RENESAS TECHNICAL UPDATE

Product Category	MPU&MCU	Document No.	TN-SH7-A590B/E	Rev.	2.00
Title	Errata of example of connection with a pulse transformer in SH7619 group hardware manual (2)		Information Category	Technical Notification	
Applicable Product	R4S76190B125BG, R4S76190B125BGV R4S76190N125BG, R4S76190N125BGV R4S76190W125BG, R4S76190W125BGV R4S76190D125BG, R4S76190D125BGV	Lot No.	Reference Document	SH7619 Group Hardware Manual Rev.4.00 (REJ09B0237-0400)	
		ALL

Figure 22.11 Example of Connection with a Pulse Transformer (RJ45)

Figure with error

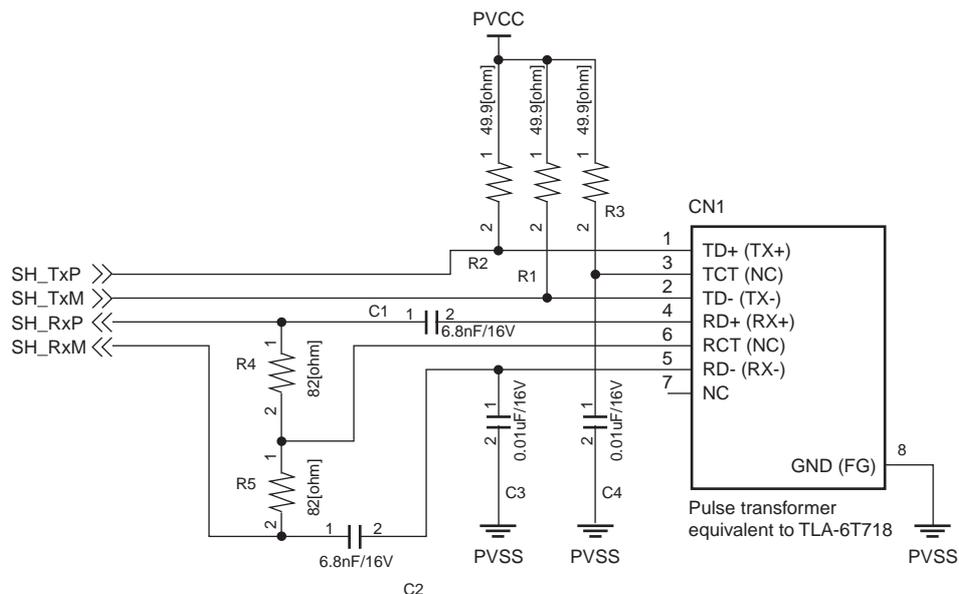
- Pin No.5 of CN1 (RD- (RX-)) is connected to ground via C3 (Already reported)
- R3 : 49.9[ohm]
- C4 : 0.01uF/16V
